ITS:6339

219 Engine and Transmission

Rework Heat Exchanger Cabin Loop Line and Routing

Figure 2: Cabin Heat Coolant Tube Removal

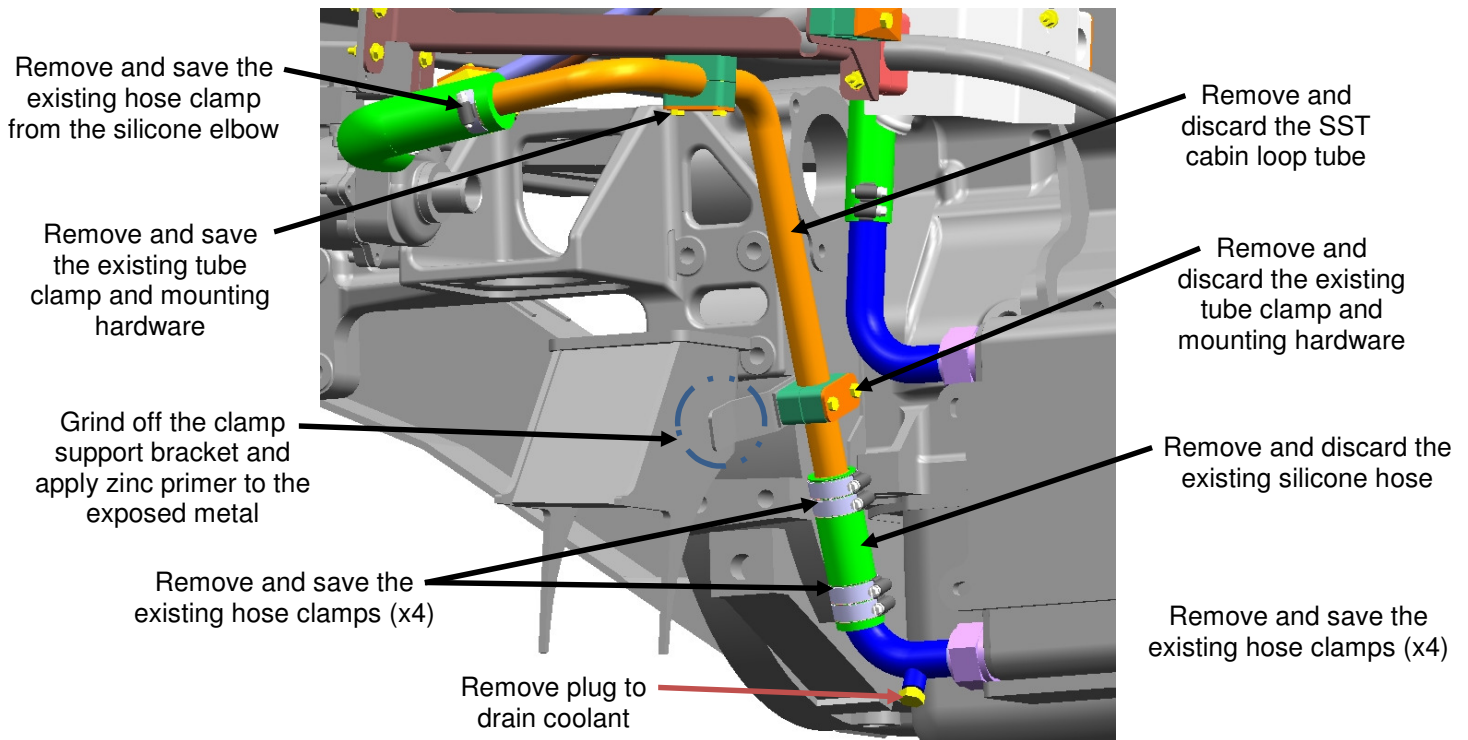
4. Place a suitable container under the heat exchanger cabin loop drain plug. Remove and save the drain plug and drain cabin heat coolant circuit. See Figure 2.

5. If necessary, raise the coach in accordance with the New Flyer Service Manual.
6. Remove and save the existing tube clamp and mounting hardware supporting the heat exchanger cabin loop SST tube to the degas frame as shown in Figure 2.

7. Remove and discard the existing tube clamp and mounting hardware supporting the heat exchanger cabin loop SST tube to the engine mount as shown in Figure 2.

8. Remove and save the existing hose clamp from the silicone elbow on the booster pump line to the SST cabin loop tube, see Figure 2.
9. Remove and save the existing hose clamps (x4) from the silicone hose connecting the heat exchanger 90° SST elbow to the SST tube to the booster pump, see Figure 2.

10. Remove and discard the existing silicone hose and SST cabin loop tube, see Figure 2.
11. Locate and grind off the clamp support bracket welded to the engine mount, see Figure 2.

Figure 3: Cabin Heat Coolant Tube Installation

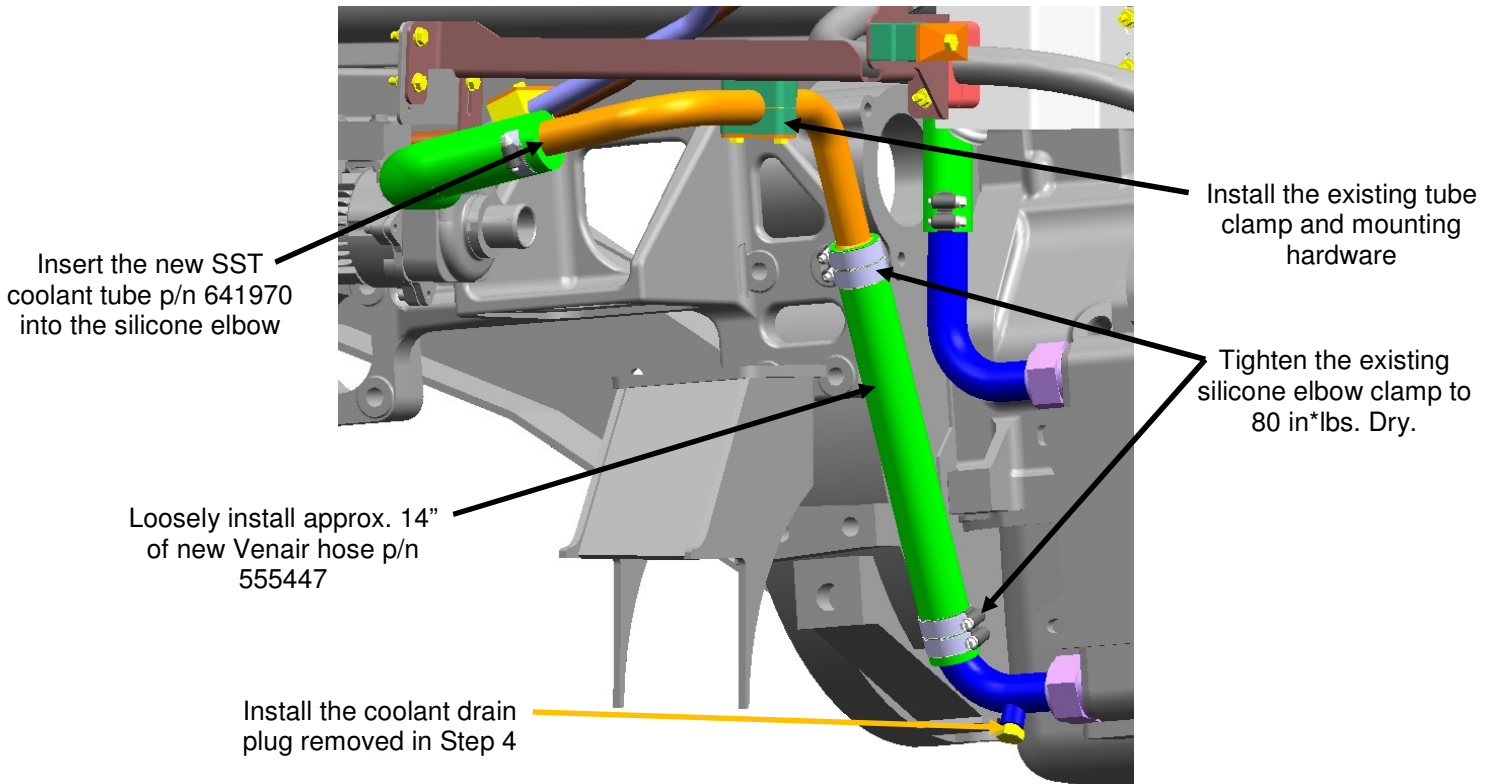
13. Insert the new SST coolant tube p/n 641970 into the silicone elbow at the booster pump. Loosely install the hose clamp removed in Step 7. Use Loctite 243 p/n 081034 on threads of hardware, see Figure 3.

14. Loosely install the existing tube clamp and mounting hardware in the same location as removed in Step in Step 6, see Figure 3.
15. Loosely install approx. 14" of new Venair hose p/n 555447 (trim hose to fit) between existing heat exchanger cabin heat SST elbow and newly installed tube from Step 14 using existing hose clamps removed in Step 9, two (2) at each end of the hose.

16. Ensure the hose and tube is free of kinks and routed in a relaxed state and tighten clamps as follows.
 - a. Tighten existing tube clamp support hardware installed in Step 14.

- b. Tighten the existing silicone elbow clamp from Step 13 to 80 in*lbs. Dry. Tighten at 75 rpm or less, re-torque to 80 in*lbs. at 75 rpm or less after 30 mins.

- c. Tighten the existing silicone hose clamps from Step 15 to 80 in*lbs. Dry. Tighten at 75 rpm or less, re-torque to 80 in*lbs. at 75 rpm or less after 30 mins.
